MINERALS PROGRAM INSPECTION REPORT

MINE NAME: Cresson Project	MINE/PROSPECTING ID#: M-1980-244	MINERAL: Gold	COUNTY: Teller
INSPECTION TYPE: Monitoring	INSPECTOR(S): Timothy Cazier, P.E.	INSP. DATE: September 28, 2021	INSP. TIME: 09:30
OPERATOR: Cripple Creek & Victor Gold Mining Compa	OPERATOR REPRESENTATIVE: Jeana Ratcliff	TYPE OF OPERATION: 112d-3 - Designated Mining Operation	
REASON FOR INSPECTION: Normal I&E Program	BOND CALCULATION TYPE: None	BOND AMOUNT: \$209,491,188.00	
DATE OF COMPLAINT: NA	POST INSP. CONTACTS: None	JOINT INSP. AGENCY: None	
WEATHER: Clear	INSPECTOR'S SIGNATURE: 	SIGNATURE DATE: October 29, 2021

Photo 7. ECOSA access road constructed containment berm near ECOSA Seep #2 (looking SE).

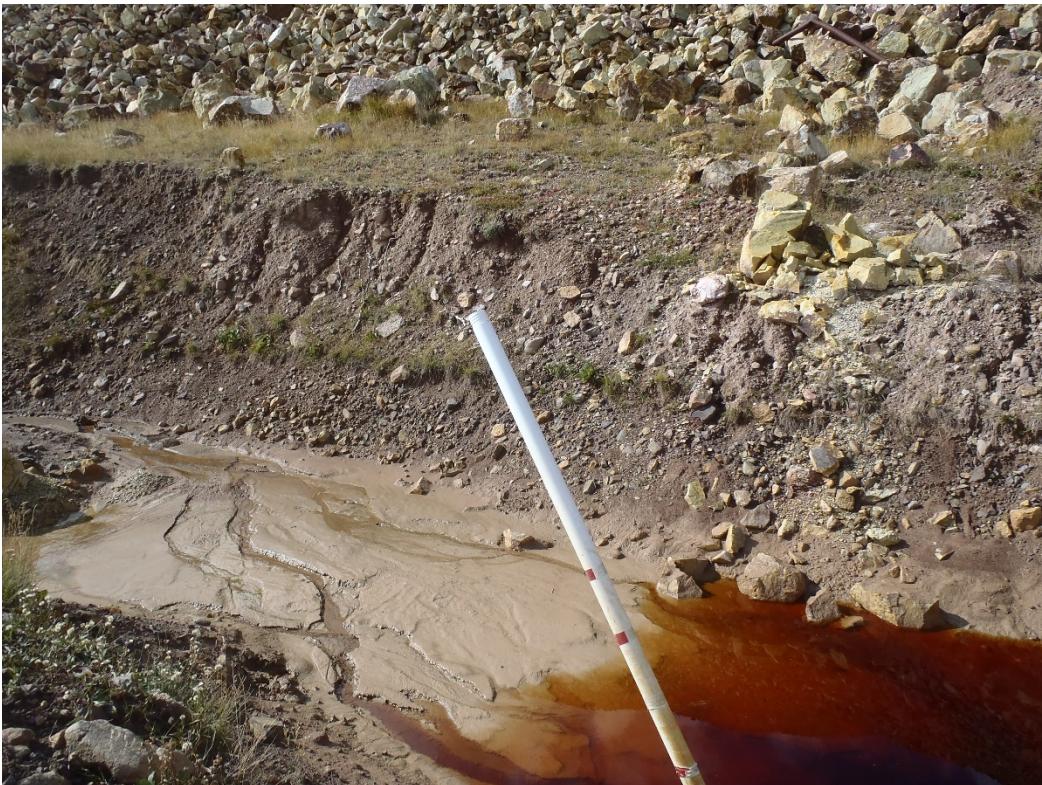
ECOSA Seeps: Ms. Ratcliff and Ms. Maria Bujenovic accompanied the DRMS to the ECOSA toe to observe the status of two seeps. The north ECOSA seep has two small collection ponds designated ECOSA Seep #2A (see **Photo 5**) and #2B (see **Photo 6**) by CC&V. Ms. Bujenovic stated they had observed about a 2-day lag between heavy rain and seepage expression in these two new seeps. She said based on field measurements the pH of the seepage water was 2.99. Site representatives pointed out a berm constructed on the east side of the ECOSA toe access road to control seepage (see **Photo 7**). The south ECOSA seep, now designated ECOSA Seep #1 was observed to have negligible inflow (see **Photo 8**). Both seeps are clearly a result of acid mine drainage (ARD) from the ECOSA. CC&V believes the placement of growth media on the ECOSA will reduce or eliminate the seeps. However, the current stormwater controls for the ECOSA as placed on the south end (see **Photo 9**) are inadequate as observed by the excessive erosion gully. [The DRMS strongly recommends CC&V recover eroded growth media at the toe of the south end of the ECOSA for future reclamation.](#) The sitewide stormwater management plan for reclamation committed to by CC&V with the approval of amendment 11 is overdue and should be prioritized given the ongoing concurrent reclamation effort.
